A-Mehr Inc.

May 13, 2020

SUBJECT: RESPONSE TO COMMENTS, PHASE III SWFP APPLICATION, CENTRAL MAUI LANDFILL (CML)
SOLID WASTE MANAGEMENT PERMIT LF-0074-13

Figure 3-6 Watkins-Gaube Graph

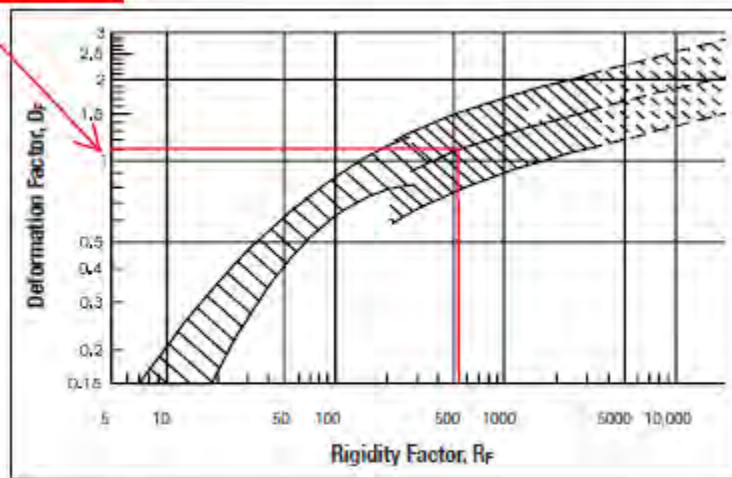
3. Please provide the crushing calculations for the LCRS pipe. Calculations should take into account perforations in the SDR 11 HDPE pipe.

Next, the designer determines the Deformation Factor, DF, by entering the Watkins-Gaube Graph with the Rigidity Factor. See Fig. 3-6. The Deformation Factor is the proportionality constant between vertical deflection (compression) of the soil layer containing the pipe and the deflection of the pipe. Thus, pipe deflection can be obtained by multiplying the proportionality constant DF times the soil settlement. If DF is less than 1.0 in Fig. 3-6, use 1.0.

Df SDR 11 = 1.1

Rf SDR11 = 533

Project Calculated Value: % Deflection = $D_F \times \varepsilon_S = 1.1 \times 8.26 = 9.08\%$

Allowable deflection, based on observed field performance of HDPE pipe, can exceed 25% with no signs of wall buckling, cracking, or splitting. Pipe is within acceptable limits.

Attachment 2 – Updated HELP Model Analysis of Phase II Slope Improvements with Rain Cap

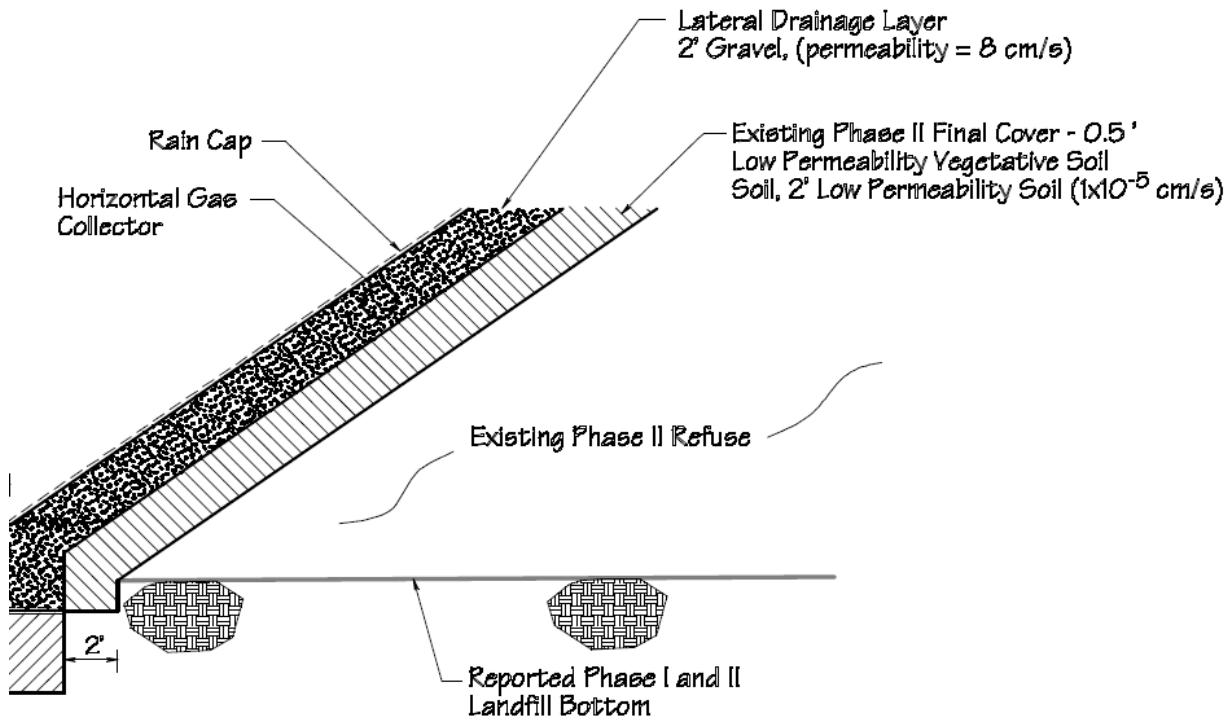
5. Is there a concern with stability on the interface of select waste placed over the rain cap (over Phase II) due to waste saturation or leachate mounding? If there is no lateral drainage layer between the waste and rain cap, is it expected that the rain cap will be punctured sufficiently as it appears to be modeled in the HELP analysis (no barrier layer included in model)?

The leachate mounding is not expected over the Phase II area due to the steep slope condition of the area and relatively high hydraulic conductivity of refuse. To be conservative, in our original HELP Model analysis we did not include the rain cap so that we could calculate a maximum leachate head over the area. To address this comment, we prepared an updated HELP Model analysis incorporating the rain cap material. It should be noted that the rain cap material is not intended to be a liner but rather used to prevent rain water intrusion into the underlying lateral drainage layer prior to being covered by refuse and will be in direct contact with the overlying refuse.

The results of the updated HELP Model analysis is presented in Table 3, Attachment 2 and indicates no leachate head build up on the rain cap layer during the 10-year operational period and a head on the rain cap of 0.042 inches during the 30-year operational period.

The following presents updated HELP Model analysis of the Phase II slope improvements. The model profiles have been updated to include the rain cap (Dura Skrim 12WB) and are summarized on the model input Table 1 and Table 2. All other profile materials and weather conditions remain the same from the prior model submitted with the original permit application package. The detail below illustrates the Phase II slope improvement components in cross-section.
